# METROPOLITAN GOVERNMENT OF NASHVILLE AND DAVIDSON COUNTY

## STAFF RECOMMENDATION

307 West End Place

**Application:** New Construction – Accessory Structure

**PLOT PLAN  
PROPOSED DETACHED GARAGE**

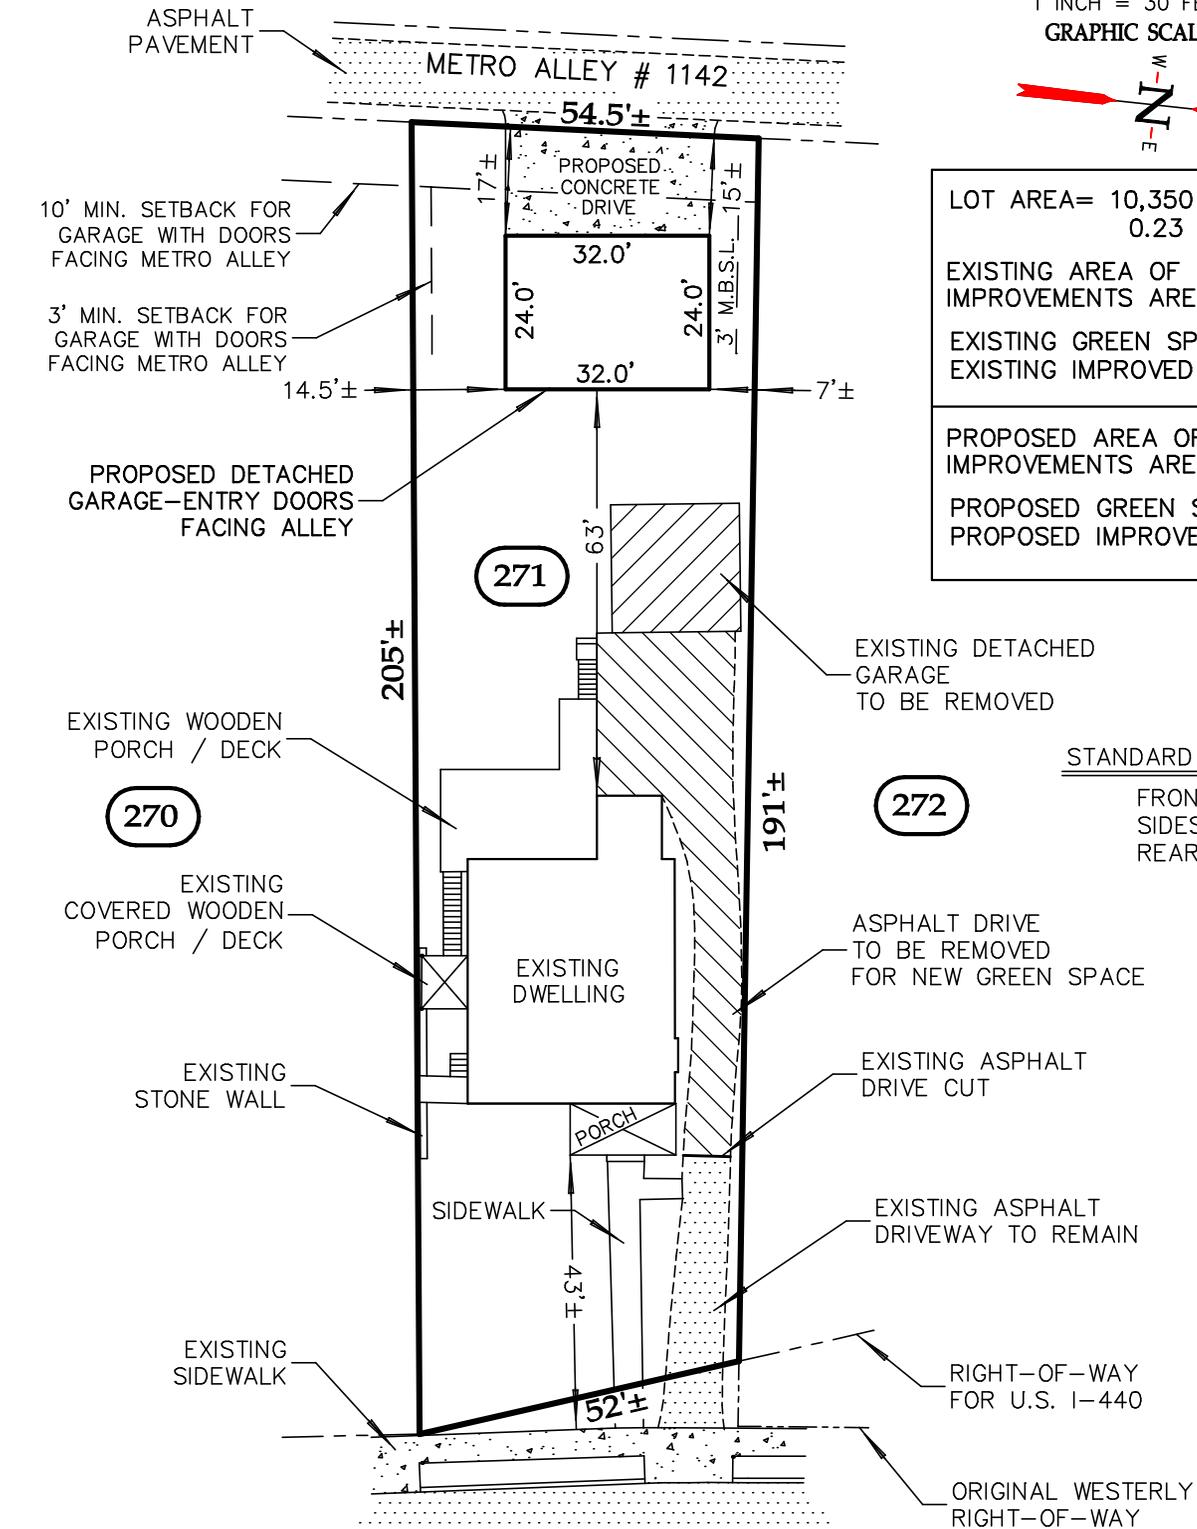
The structure will be located at the rear of the lot, fifteen feet (15') forward of the rear property line, and seven and fourteen feet (7', 14') from the right and left property lines, respectively. This is compatible with the locations of historic accessory structures and meets guidelines II.B.1.c, II.B.1.f and II.B.1.h.2 (Setback and Rhythm of Spacing, Orientation, Outbuildings), and the existing setback requirements.

The submitted site plans show the existing driveway being removed from along the side of the house, leaving a paved parking area from the street to the front of the house. Typically throughout the historic district, driveways either run all the way back to an accessory structure, or are not present at all. Staff would recommend that the driveway either be removed entirely, or that it be left intact roughly thirty feet (30') longer, so that it reaches the mid-point of the house.

1. Additional information about the door material and roof color be provided and approved by staff,
2. The driveway shall extend to the midpoint of the structure if not removed entirely;

LEFT ELEVATION  
1/8" = 1'-0"

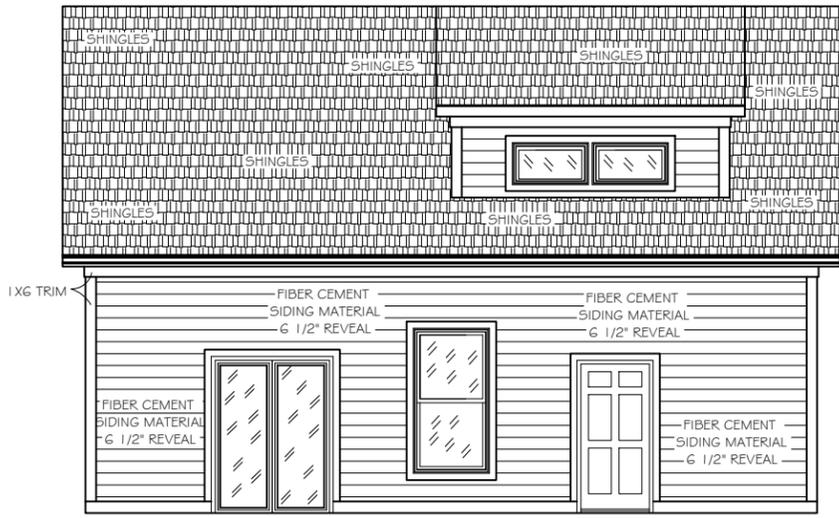
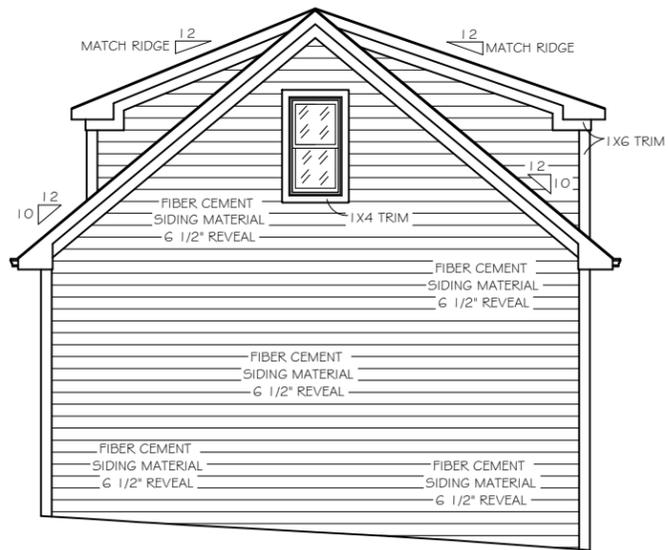
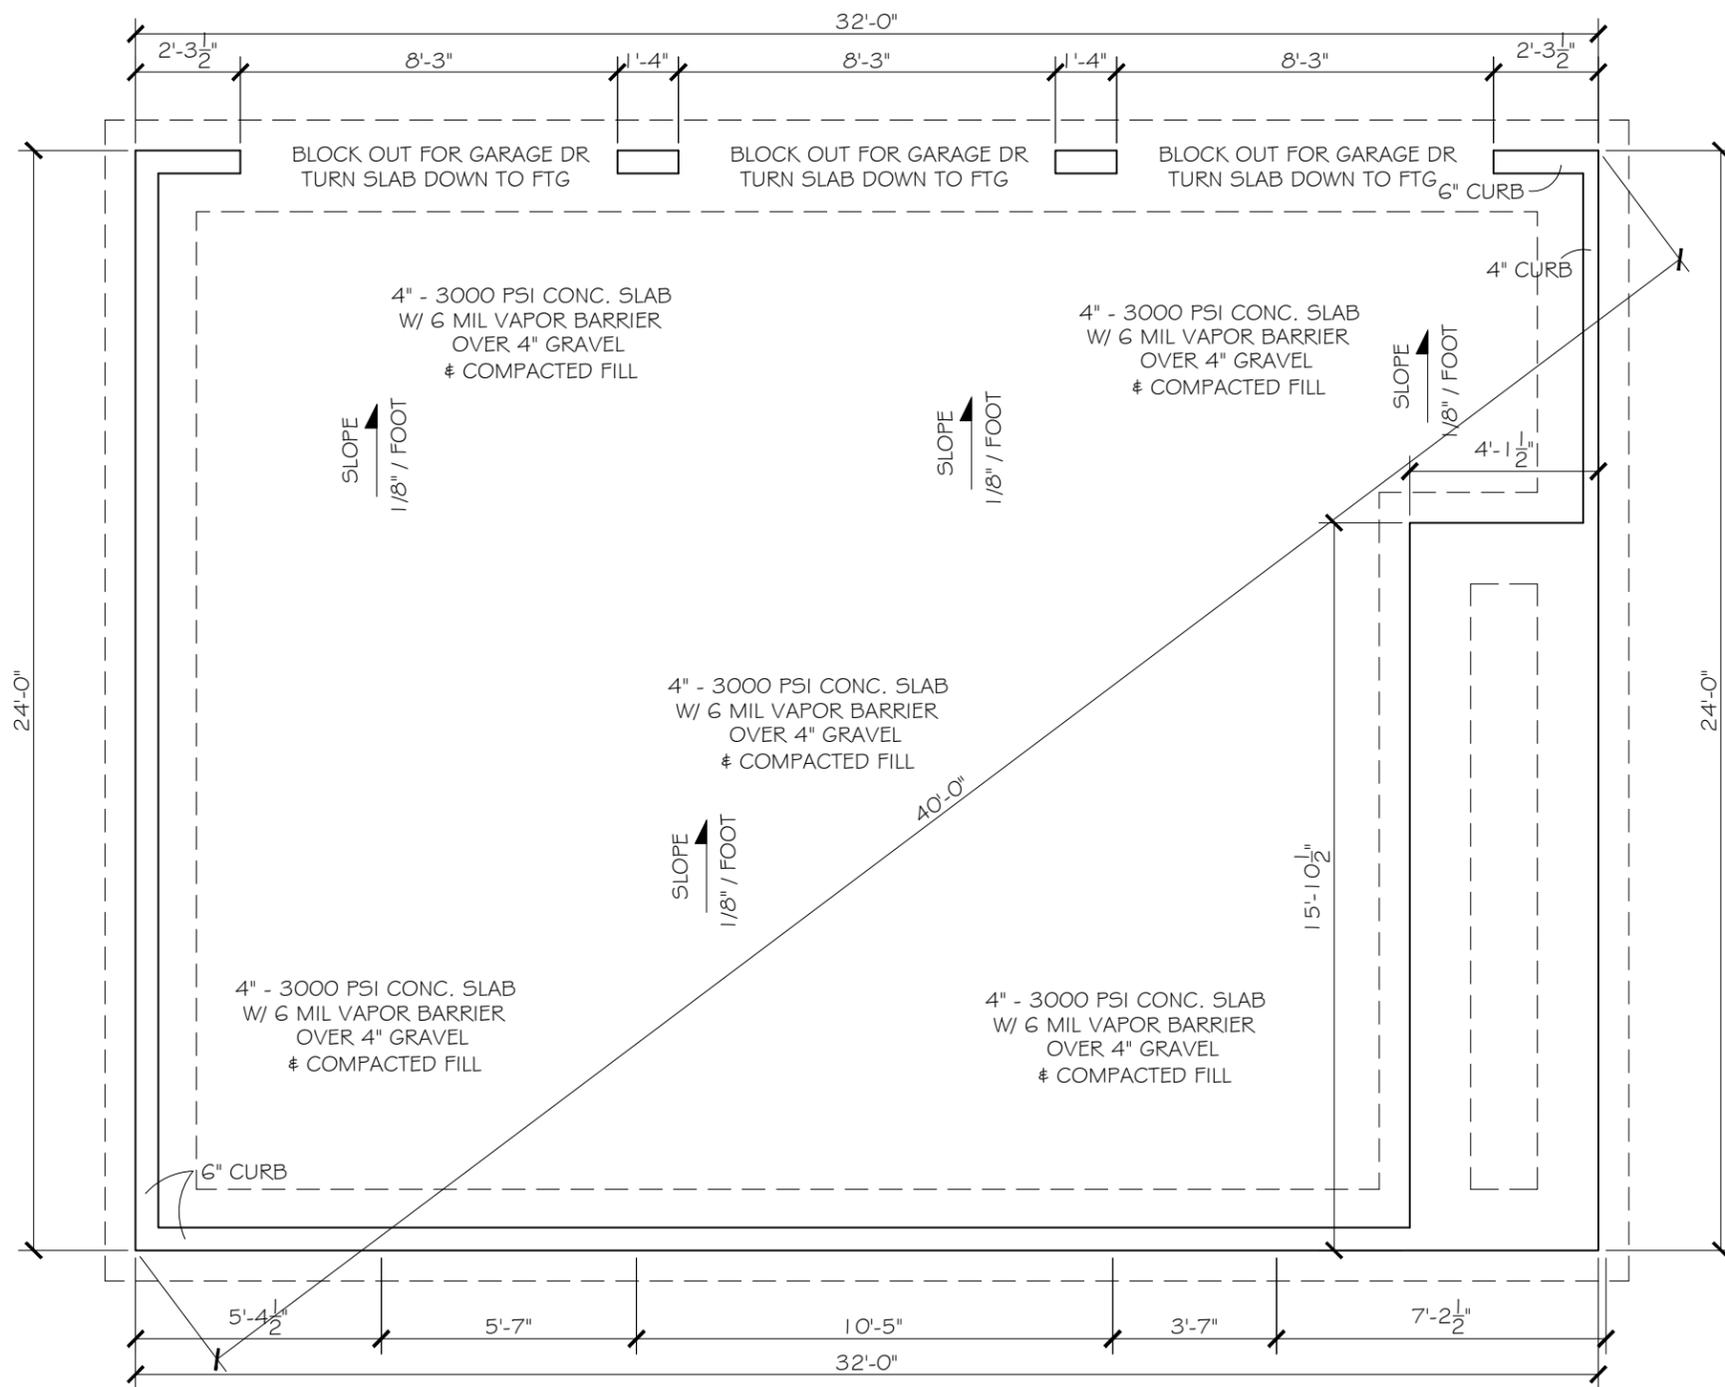
The new garage will be twenty-two feet (22') tall at the front, measured from grade to the peak of the roof, with an eave line eleven feet (11') above grade. This will be three feet (3') shorter than the height of the house, not accounting for a significantly lower grade at for the garage because the lot drops approximately twelve feet (12') toward the rear. The structure will be thirty-two feet (32') wide across the front by twenty-four feet (24'). This width matches the width of the house. The area of the structure, seven hundred, sixty-eight square feet (768 sq. ft.), is approximately forty-nine percent (49%) of the footprint of the primary structure. Staff finds the proportions of the structure to be compatible and to meet guidelines II.B.1.a and II.B.1.b. (Height, Scale).

The primary cladding material on the garage will be smooth-faced cement-fiber siding, with an exposure matching the siding on the house. The foundation will be poured concrete slab and the roof will be asphalt shingles. The windows, doors, and trim will be wood. These materials are compatible with surrounding historic accessory structures and meet guideline II.B.1.d and II.B.1.h.1 (Materials, Outbuildings). Additional information on the material of the doors and roof color will need to be provided and approved by staff before a permit is issued.

The roof will be a side-oriented gable with a 10:12 pitch, a pitch not uncommon in the overlay. The front slope of the roof will have a shed-roofed dormer set two feet (2') back from the front wall, meeting the primary roof at the ridge. Although dormers on primary structures are typically set below a roof ridge, staff finds the location to be appropriate on an accessory structure at the rear of a lot, and the roofs to meet guideline II.B.1.e (Roof Shape). There will also be a shed-roofed dormer on the rear, but it will not be visible from the right-of-way.

Staff recommends approval of the new accessory structure with the conditions that:
